## **STAFF REPORT**

For the Meeting of June 11, 2025

Supplemental Information

Replat- 4N2802AB Replat of Sunset Estates & Terra Nova Terrace

SUNNY VIEW TERRACE

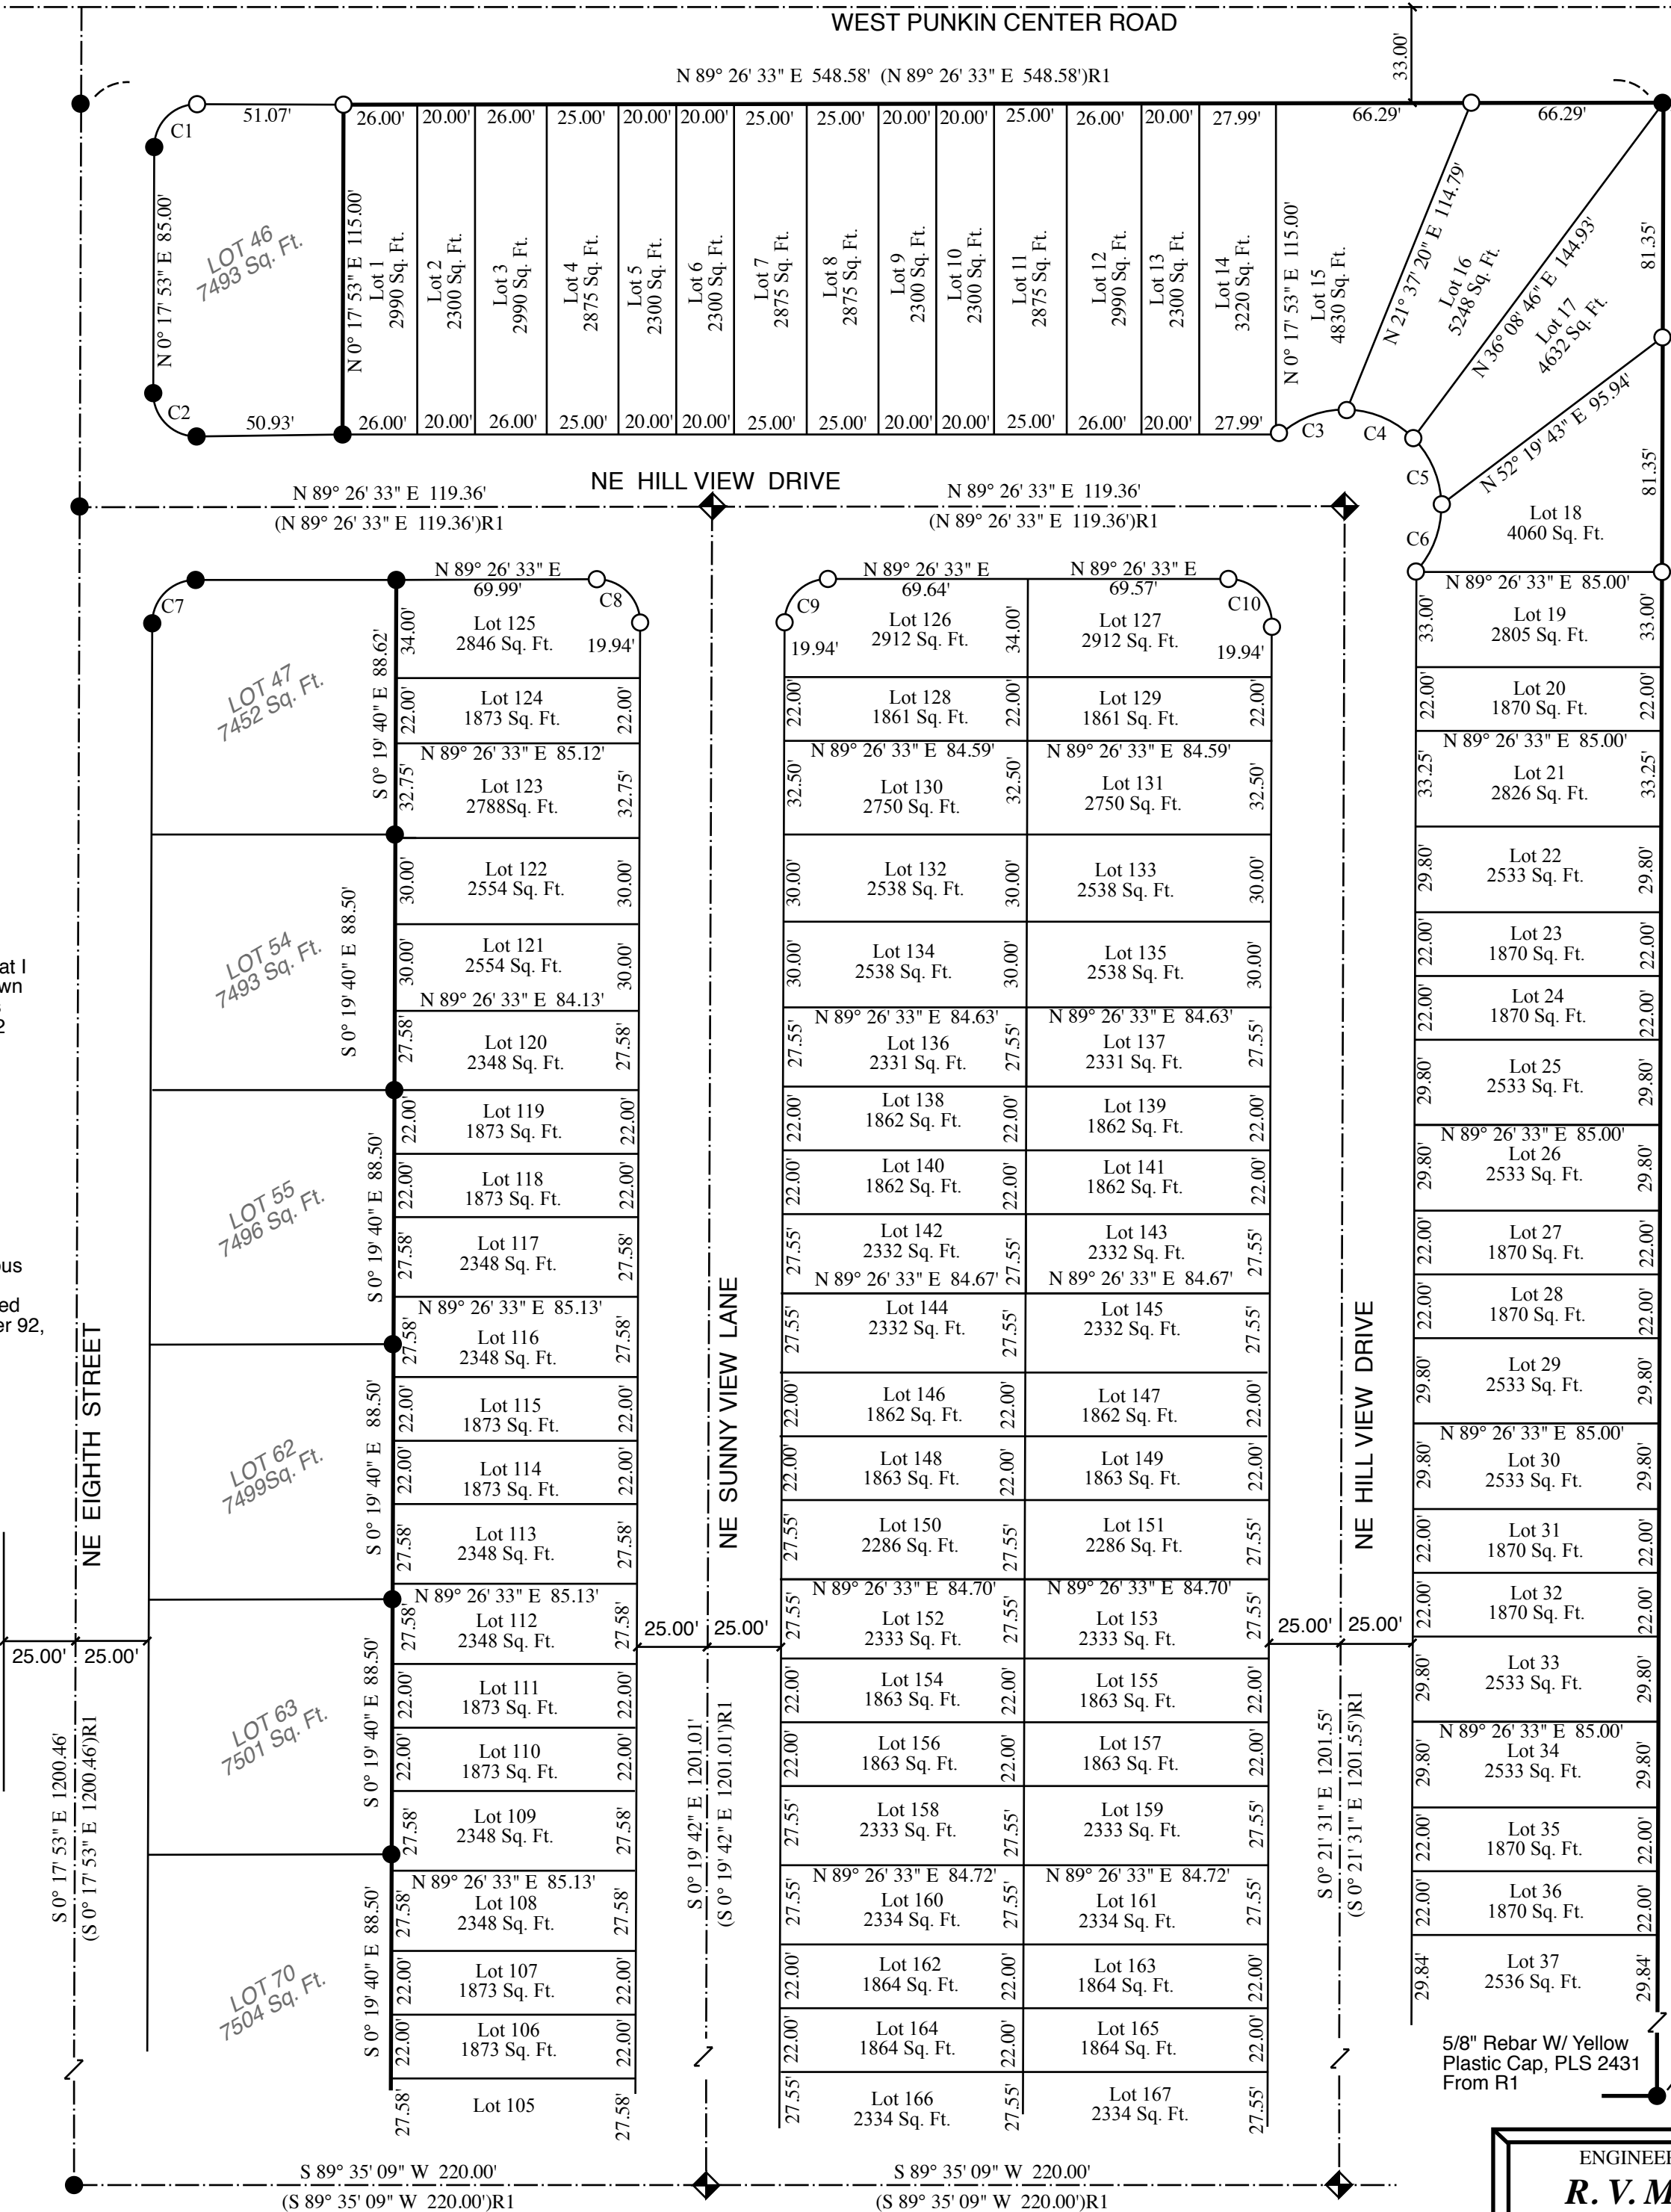
The staff report for this replat issued on June 4 identified an issue with tri-plex lots in the development. The tri-plex lots had an area deficiency, and the staff report recommended that the planning commission require the deficiency to be fixed or a new plat to be submitted. The applicant has submitted a revised plat which increases the lot sizes for the tri-plex lots to meet the 7,500 square foot minimum. The aggregate of all three-family lots now varies between 7,501 and 7,525 square feet. Two- and four-family lots continue to comply with minimum lot size requirements of 5,000 and 8,000 square feet respectively. Staff recommends that condition #5 in Exhibit B to the staff report be removed and subsequent conditions renumbered accordingly.

Revised maps have been prepared by staff indicating the potential layout of common wall dwellings on the site. The overall number of lots has been reduced from 219 to 213 in order to comply with the aggregate minimum lot size requirement.
